Thank you for the opportunity to review the public comment draft Remedial Investigation (RI) report for the Glacier Northwest Site (Glacier NW Site), which is located along the western shore of the Lower Duwamish Waterway (LDW), immediately north adjacent to the Port of Seattle's (Port) Terminal 115 (T-115). The T-115 property encompasses two MTCA cleanup sites – North Terminal 115 (T-115 North) and Terminal 115 Plant 1 (T-115 Plant 1)– both being addressed under separate Agreed Orders (AOs).

The Port is submitting the following comments on the Glacier NW Site draft RI report (draft RI). For Ecology's reference, figures that present arsenic and pentachlorophenol (PCP) occurrences in shallow and deep groundwater near the Glacier NW and T-115 property line, a cross section and a focused conceptual site model (CSM) that span the property line are attached to accompany our comments.

Cmt No.	RI Section	Statement in Draft RI	Port Comment
1	2.2	*Although Terminal 115 and North Terminal 115 are separate sites with individual MTCA orders (Order No. 18064 and Order No. 8099, respectively), the two sites will be referred to jointly as "T115" hereon.*	Refer to the two T-115 sites separately

FIGURE 5

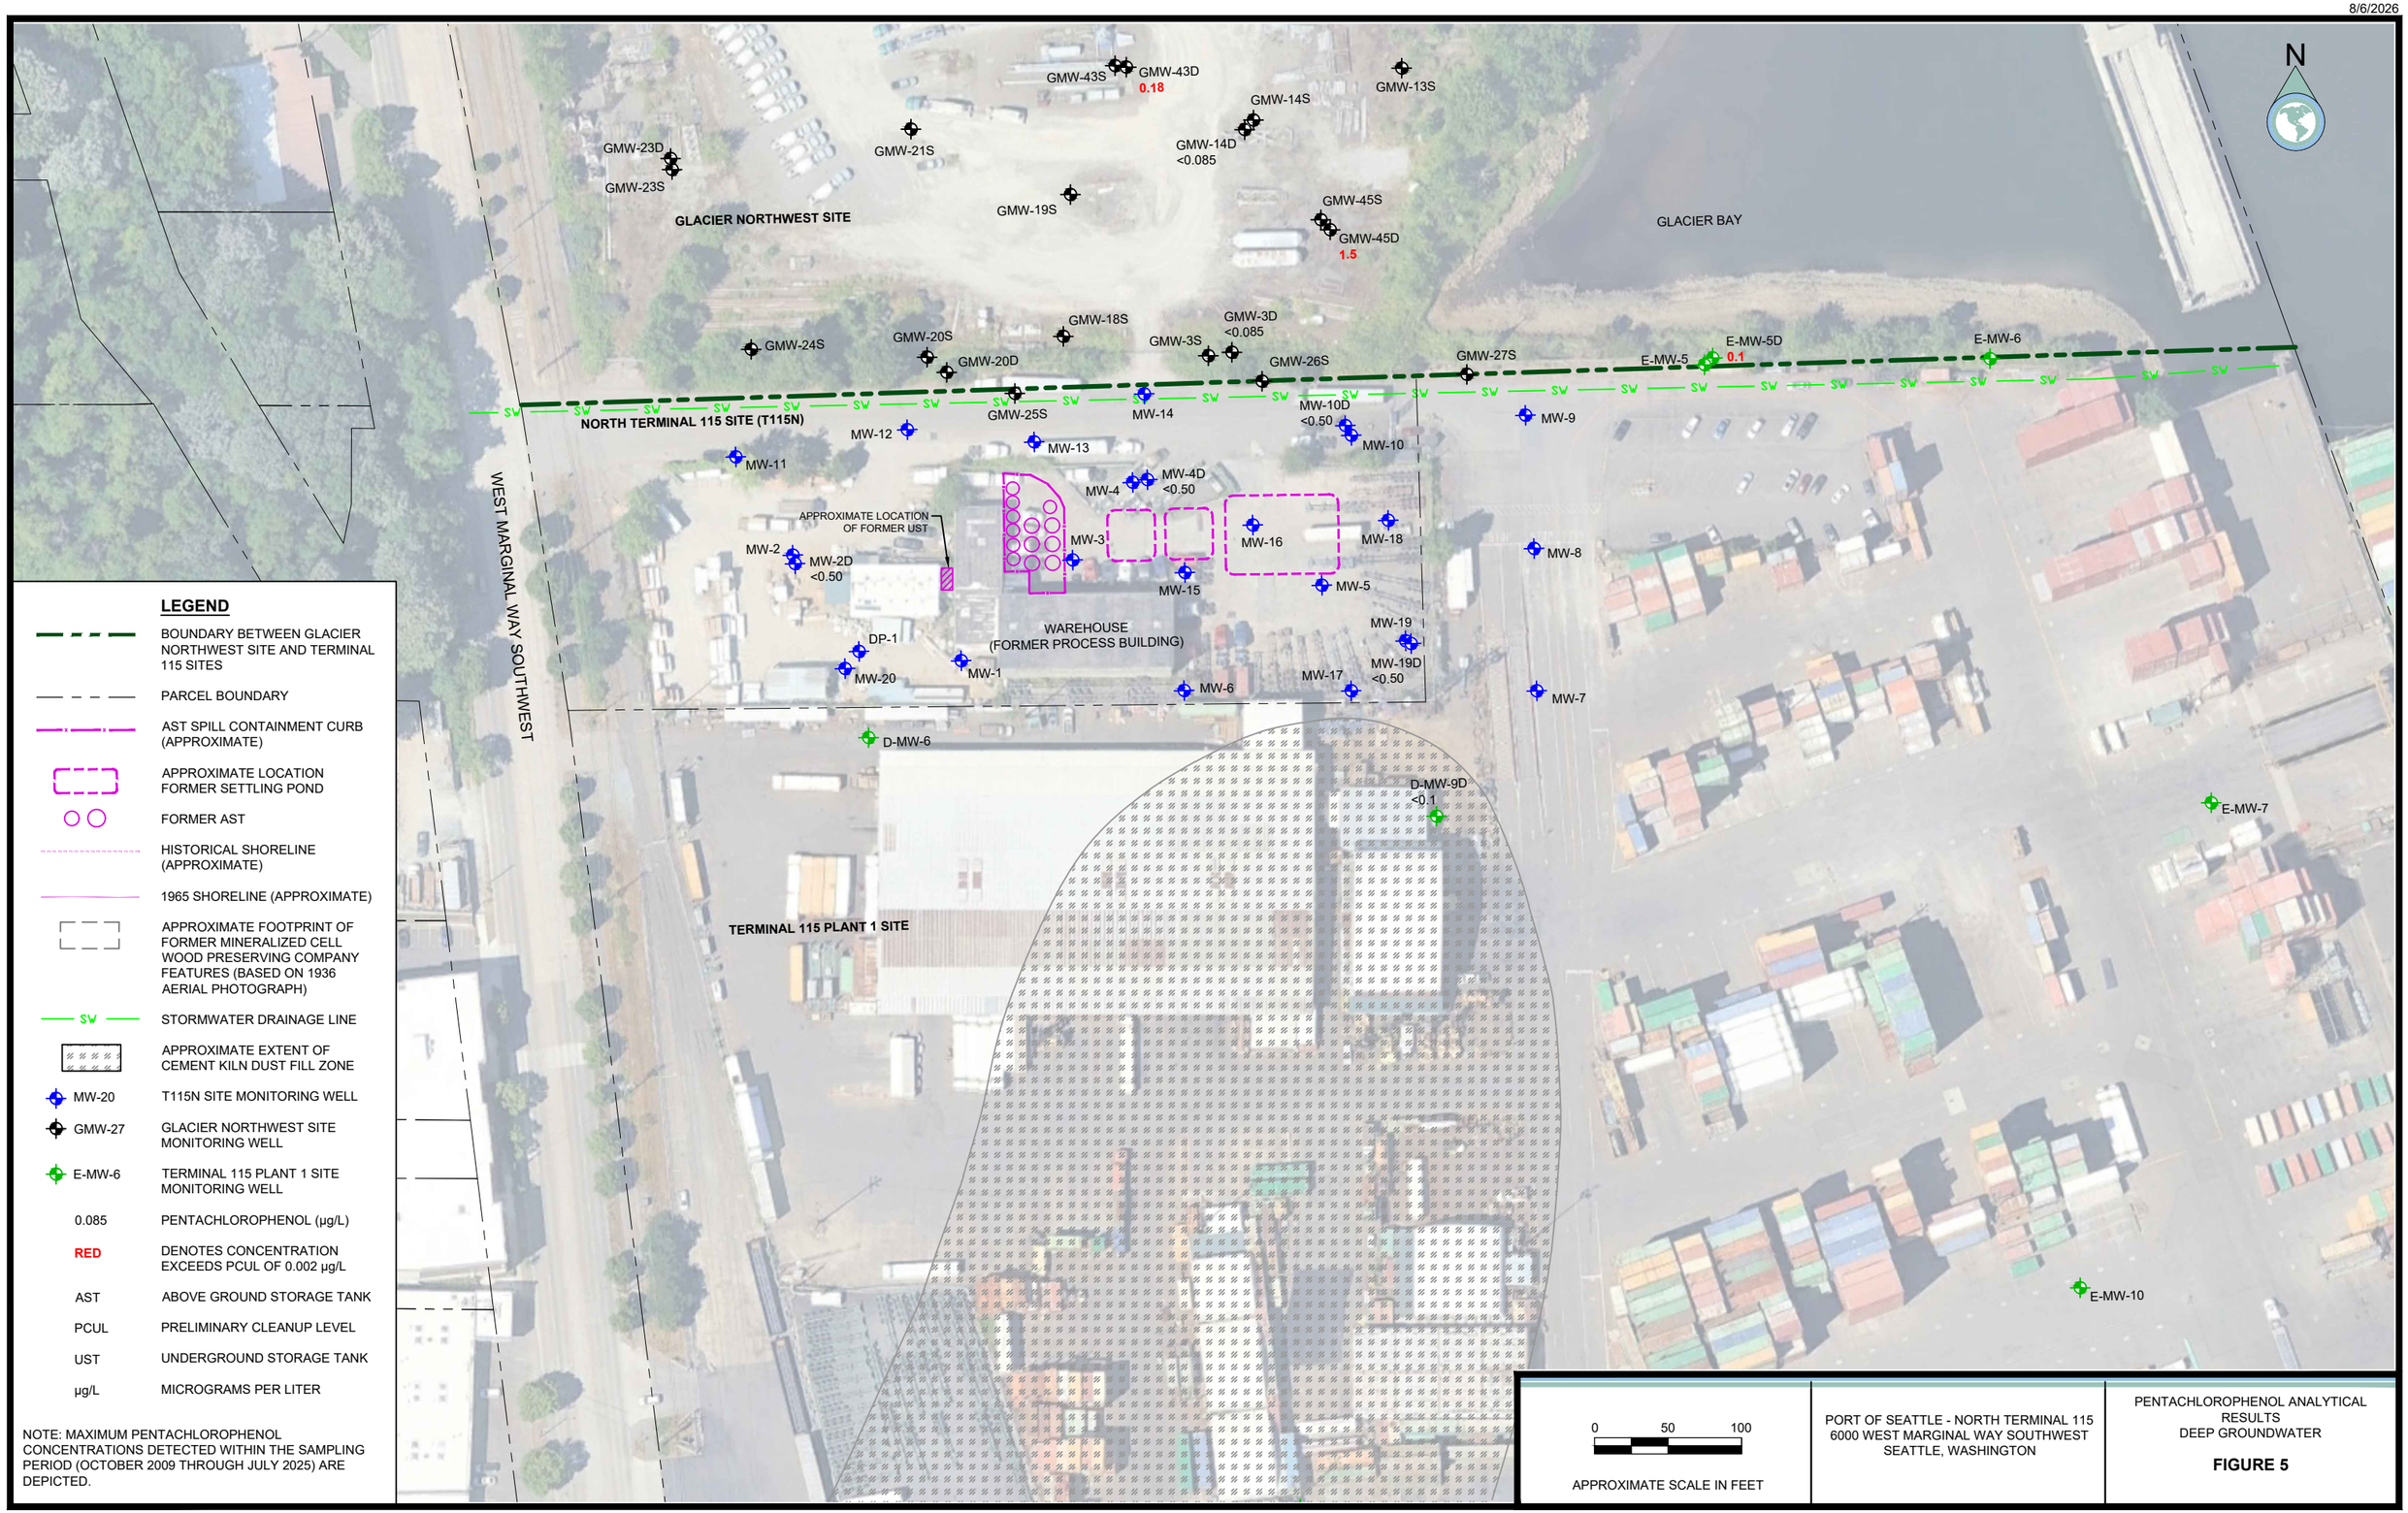
• Similarly, PCP is present at concentrations greater than SLs in shallow groundwater on the T-115 North Site, which likely originated from former Reichold operations on the Glacier NW property from 1946 to 1961 (Section 2.6.6 of the draft RI). PCP concentrations in shallow groundwater on the Glacier NW property are generally one or more orders of magnitude higher than PCP concentrations detected on the T-115 North Site.
			  ○ Section 5.2.4.1 of the draft RI states: "PCP SL exceedances occur in shallow groundwater on the Port of Seattle property in monitoring wells MW-15, MW-16, and MW-10, and are bounded by monitoring wells MW-4, MW-3, MW-6,
